# GUAM POWER AUTHORITY

## AMENDMENT NO.: II

REQUEST FOR INVITATION FOR BID NO.: GPA-061-10

**SMOKE STACK ASSEMBLY REPLACEMENT FOR DEDEDO COMBUSTION TURBINE NO. 1  
POWER PLANT**

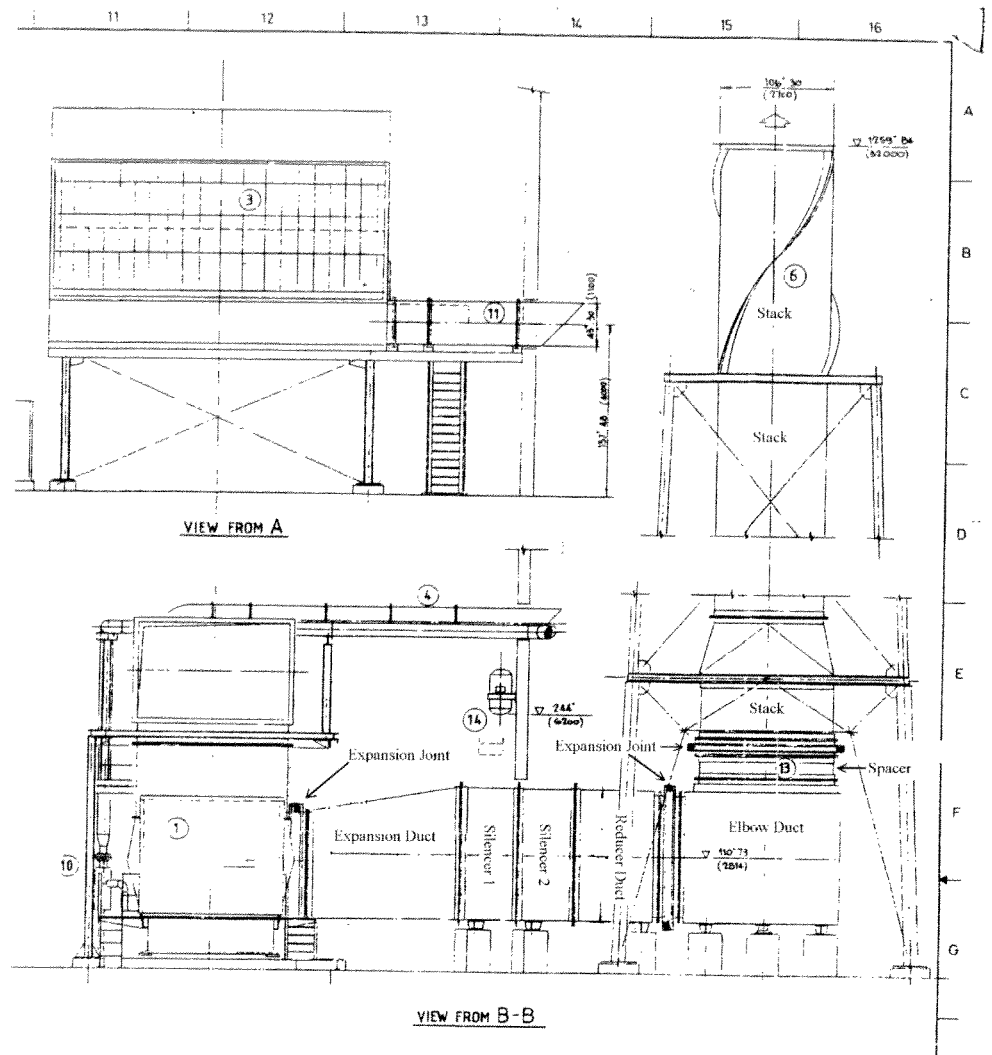
4. How many Exhaust Ducts need to replace or repair?

We scan the drawing # 0022A4001 page 117 of 238 then edit and put the name for each duct as shown below. Base on the sight of site visit, the Expansion Duct, Silencer Ducts, Reducer Duct, Elbow Duct and Space Duct all of them need to replace or repair? The Expansion Duct, Reducer Duct, Elbow Duct and Space Duct seems be in good condition and the two sections of silencer already burn through. Please clarify which exhaust duct(s) need to replace?

Note: The name we put for each duct might not be the same as original definition.

Original Scope of Works (SOW), page 84 of 238, item no. 4 calls for the replacement of the entire exhaust ducts, and item no. 5 of SOW, same page, new fiberglass insulation for ducts with 3/16 inch thick mild steel cover, supply new silencers and expansion joints. After confirming from Asst. Plant Superintendent, Anthony Santos and GPA Generations Manager, management agreed and recommends the following to reduce the cost.

- a) The two silencers must be totally replaced because it is beyond repair. Repairing these silencers will cost more.
- b) All three (3) old expansion joints must also be replaced entirely by new ones.
- c) Re-use the expansion duct, reducer duct, elbow duct, and spacer duct. (Refer to drawing section B-B below). Upgrade and repair expansion duct, reducer duct, elbow duct and spacer duct. Sandblast the duct interiors nearly to white metal cleanliness, SSPC-SP10/NACE 2, until at least 95% of the surface is free from rust and corrosion. Repair the ducts by patching where minimal thickness are evident before installing the new 6-inch thick fiberglass insulation and secure with 3/16 inch thick mild steel cover. Duct exterior surfaces shall be sandblasted conforming to SSPC-SP-10/NACE 2, and painted with epoxy paint that can withstand 1100 °F exhaust temperature.
